AGENDA
HAILEY PLANNING & ZONING COMMISSION
Monday, September 26, 2016
Hailey City Hall
5:30 p.m.

Hayes Accessory Structure (Garage and Accessory Dwelling Unit) Design Review
 Hailey Townsite, Lots 5,6 and 7 of Block 22 (313 South Second Street)
 Hailey Planning Zoning Commission – September 26, 2016
 Design Review – Page 9 of 12

SITE PLAN
1606

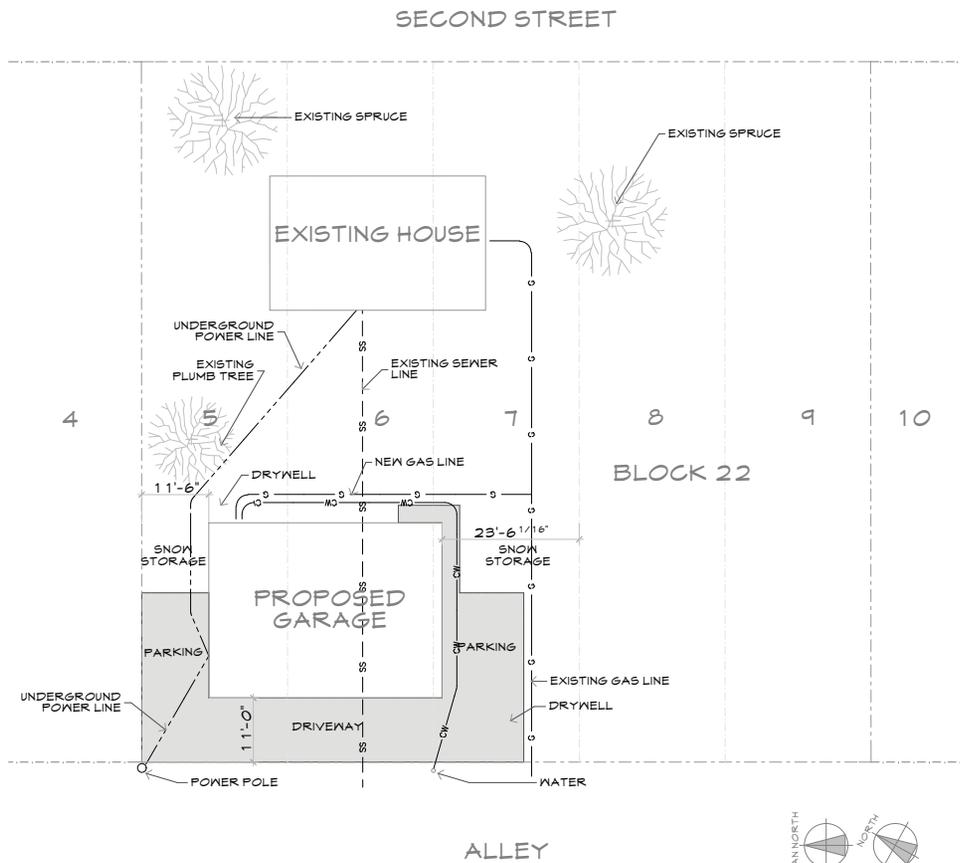
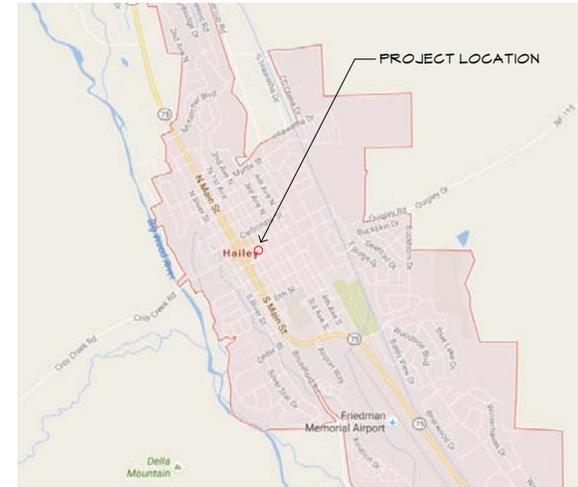
<i>Staff Comments</i>	<i>Dust-free surfaces are planned. The subject property is zoned GR.</i>
<input checked="" type="checkbox"/>	<input type="checkbox"/>	<input type="checkbox"/>	17.06.090(C)5	Guideline: Landscaping and other design elements adjacent to alleys should be kept simple, and respect the functional nature of the area and the pedestrian activity that occurs.
			<i>Staff Comments</i>	<i>The landscaping is existing.</i>
<input checked="" type="checkbox"/>	<input type="checkbox"/>	<input type="checkbox"/>	17.06.090(C)6	6. Accessory Structures
				Guideline: Accessory buildings shall appear subordinate to the main building on the property in terms of size, location and function.
			<i>Staff Comments</i>	<i>While the accessory structure has a larger footprint than the main building, it appears subordinate due to its location to the rear, and off the alley. Similar sized accessory structures have been approved in the neighborhood. This location is preferred for a garage.</i>

Staff Comments	<i>The accessory structure has been located to the rear and off the alley.</i>
<input checked="" type="checkbox"/>	<input type="checkbox"/>	<input type="checkbox"/>	17.06.090(C)7	7. Snow Storage
				Guideline: All projects shall be required to provide 25% snow storage on the site.
			Staff Comments	<i>The parking areas are calculated as 1,168 square feet of parking area, requiring 292.12 square feet of snow storage. A snow storage area is indicated on the plan which appears to be in excess of the required amount. Additional areas on Lots 5, 6 and 7 exist for snow storage.</i>
<input checked="" type="checkbox"/>	<input type="checkbox"/>	<input type="checkbox"/>	17.06.090(C)7	Guideline: A snow storage plan shall be developed for every project showing: <ul style="list-style-type: none"> • Where snow is stored, key pedestrian routes and clear vision triangles. • Consideration given to the impacts on adjacent properties when planning snow storage areas.

Staff Comments	<i>Snow storage is all on lots 5-7.</i>
<input checked="" type="checkbox"/>	<input type="checkbox"/>	<input type="checkbox"/>	17.06.090(C)8	8. Existing Mature Trees and Landscaping
				Guideline: Existing mature trees shall be shown on the site plan, with notations regarding retention, removal or relocation. Unless shown to be infeasible, a site shall be carefully planned to incorporate existing mature trees on private property into the final design plan.
			Staff Comments	<i>Two existing spruce and an existing plum are shown to be retained.</i>
<input checked="" type="checkbox"/>	<input type="checkbox"/>	<input type="checkbox"/>	17.06.090(C)8	Guideline: Attention shall be given to other significant landscape features which may be present on the site. Mature shrubs, flower beds and other significant landscape features shall be shown on the site plan and be incorporated into the site plan where feasible.

Staff Comments	<i>A variety of smaller shrubs exists on the property, and will be retained.</i>
<input type="checkbox"/>	<input type="checkbox"/>	<input checked="" type="checkbox"/>	17.06.090(C)8	Guideline: Noxious weeds shall be controlled according to State Law.
			Staff Comments	<i>Noxious weeds are not present on the site.</i>
<input checked="" type="checkbox"/>	<input type="checkbox"/>	<input type="checkbox"/>	17.06.090(C)9	9. Fences and Walls
				Guideline: Fences and walls that abut public streets and sidewalks should be designed to include fence types that provide some transparency, lower heights and clearly marked gates.
			Staff Comments	<i>A fence exists on the front and sides of the lot, and on portions of the front yard to the north. Any additional fencing would require a fence permit.</i>
<input type="checkbox"/>	<input type="checkbox"/>	<input checked="" type="checkbox"/>	17.06.090(C)9	Guideline: Retaining walls shall be in scale to the streetscape.

Staff Comments	<i>No retaining walls are proposed. A small retaining wall exists in the City right of way on Second Street to accommodate the grade change between the on-street parking and the site. No changes are proposed in this area.</i>
<input type="checkbox"/>	<input type="checkbox"/>	<input checked="" type="checkbox"/>	17.06.090(C)10	10. Historic Structures
				General Guidelines: Any alteration to the exterior of a Historic Structure requiring design review approval shall meet the following guidelines: <ul style="list-style-type: none"> • The alteration should be congruous with the historical, architectural, archeological, educational or cultural aspects of other Historic Structures within the Townsite Overlay District, especially those originally constructed in the same Period of Significance. • The alteration shall be contributing to the Townsite Overlay District. Adaptive re-use of Historic Structures is supported while maintaining the architectural integrity of the original structure.

BUILDING ELEVATIONS

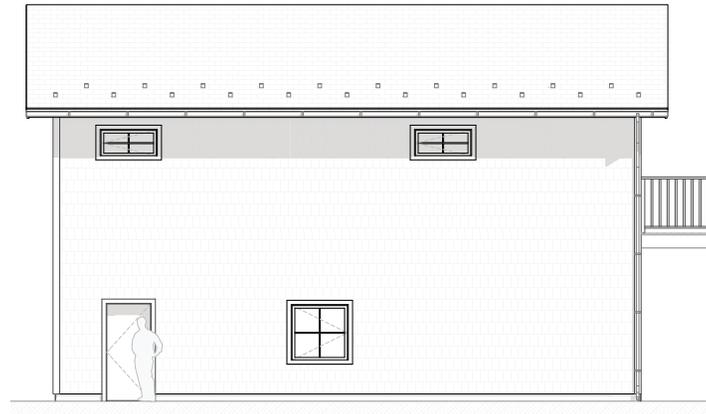
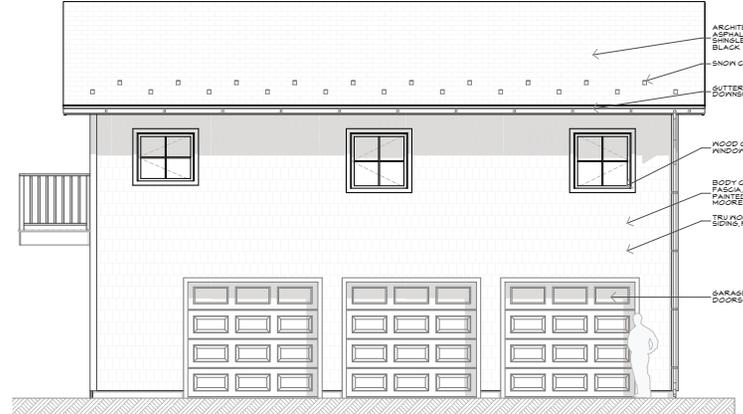
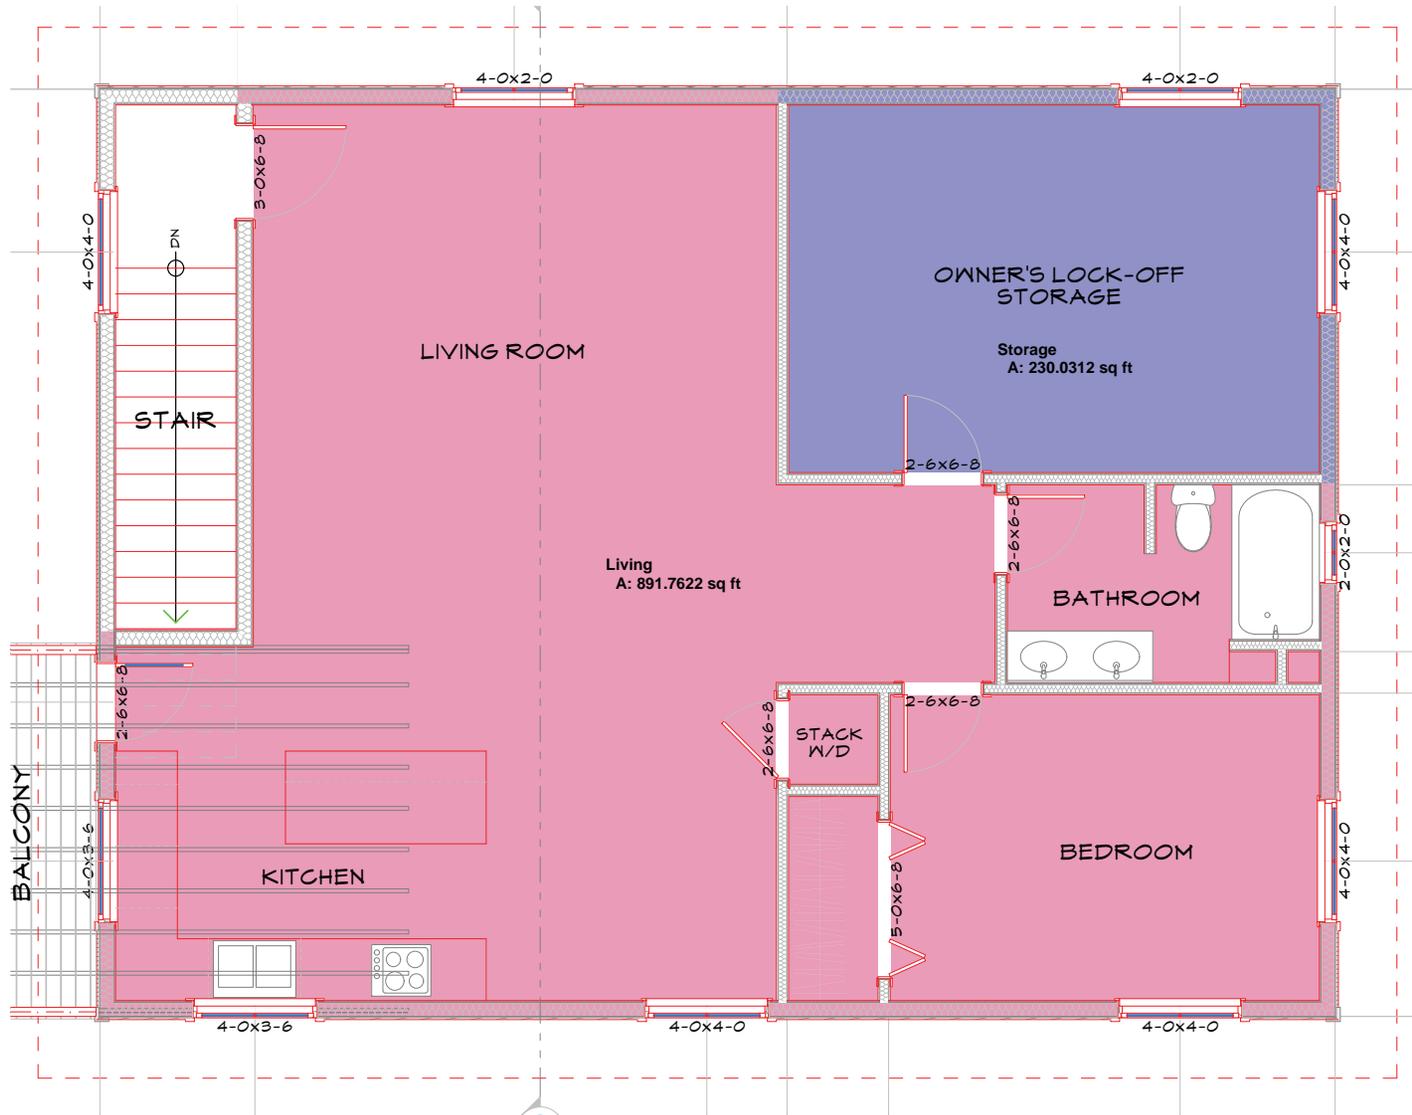
- g) The deck on the north side shall be modified such that it extends into the required side yard no more than three (3) feet.
- h) The Accessory Dwelling Unit shall not exceed 900 square feet.

WEST FACING VIEW - PROPOSED
 *PLANNING AND ZONING APPROVED BUILDING AND ENTRY ROOF 1/4" = 1'-0"

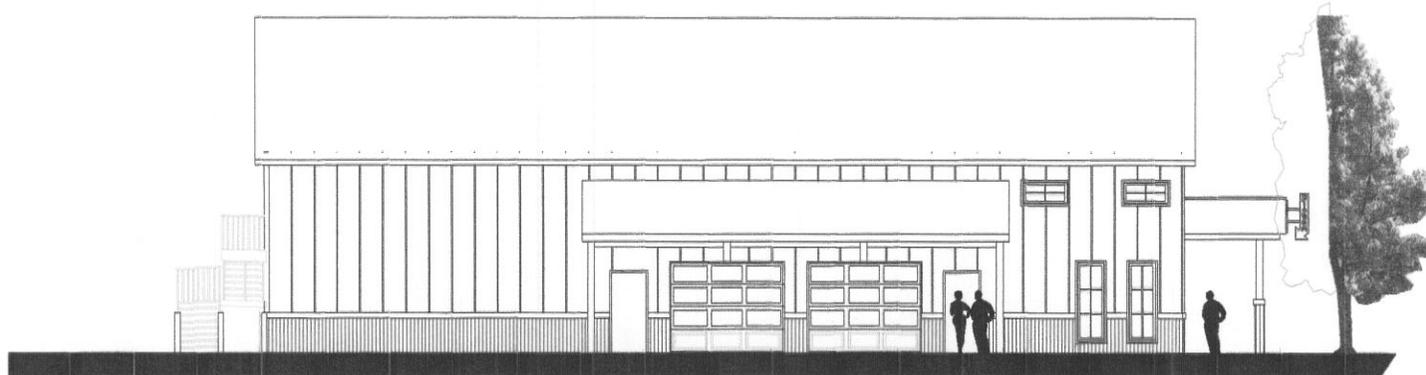
<i>Staff Comments</i>	<p><i>The site contains a variety of landscaping, shown on Sheet A-101. Five deciduous trees are proposed to be removed. One of these is a mature City Street tree. The Hailey Tree Committee members have commented, and recommend that this tree be retained, as it is in good health, is one of the nicer street trees on Main Street, and that this linden tree is part of a formal street tree design that places trees at regular intervals up and down the block, that this street tree pattern is in front of many buildings on this block, that the trees on main street create a pleasant Main Street environment, that it would set a bad precedent o allow this tree to be removed, and that it will be an asset over time for adjacent properties. Street Department staff has noted that irrigation located under the sidewalk associated with this tree could undermine the sidewalk if removed. Comments from Tree Committee members are attached to this report. The Commission confirmed that the City street trees shall remain, and that this item will be made a Condition of Design Review approval.</i></p> <p><i>An inventory of existing plant material has not been prepared. The Chair noted that the street trees have monetary value in addition to the above, and does staff know the value of this tree.</i></p>

- g) All City street trees shall be retained.
- h) A gable end element shall be added to the west elevation.
